JOB NO. 12443N — DRG. NO. DS2

☐ NO EXCEPTIONS TAKEN ☐ REJECTED
☒ FURNISH AS CORRECTED
☐ REVISE AND RESUBMIT

PROJECT NO: IM-089-2(26) STATE BRIDGE NO. 43N
MATERIAL: AASHTO M270-Gr36 ELECTRODES: PER PROC HOLES: AS NOTED SHOP BOLTS:
SURFACE PREP. & PAINT:
GALVANIZED AFTER FAB.

DESCRIPTION: DOWNSPOUTS - ABUT. 2.
JOB: BRIDGE 43N
I 89 OVER U.S. ROUTE 2
MIDDLESEX-BOLTON VT.

D43N - ONE REQ'D

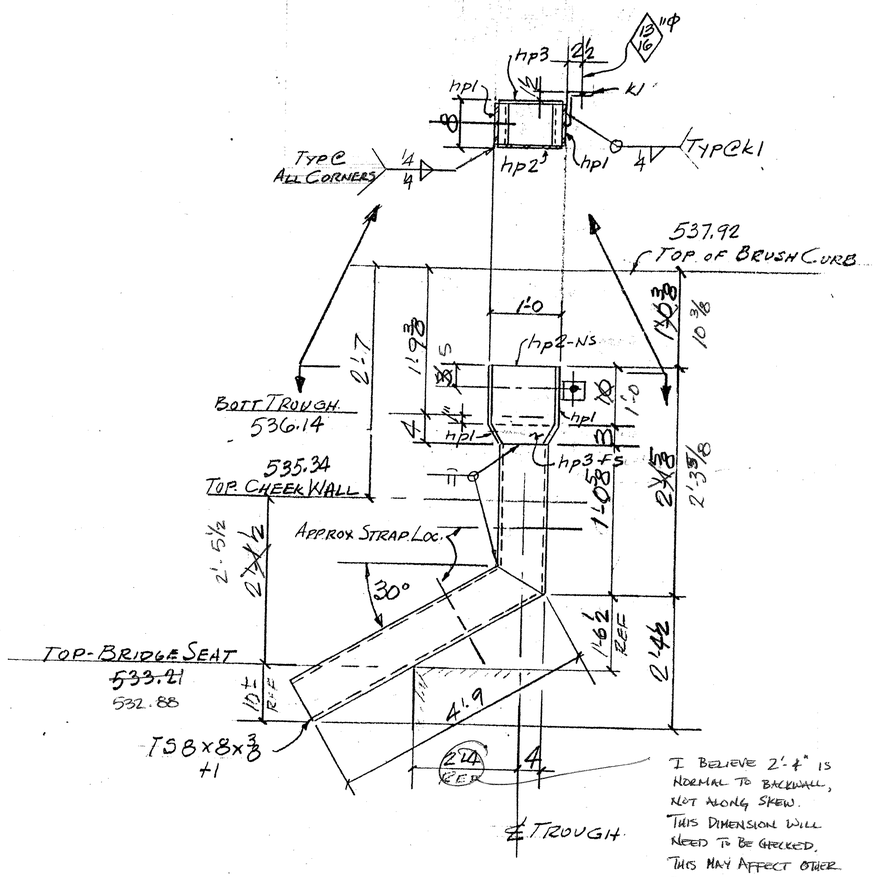
I BELIEVE 2'-4" IS NORMAL TO BACKWALL, NOT ALONG SKEW. THIS DIMENSION WILL NEED TO BE CHECKED. THIS MAY AFFECT OTHER DIMENSIONS FOR THE PROJECTING PORTION OF THE DOWNSPOUT.
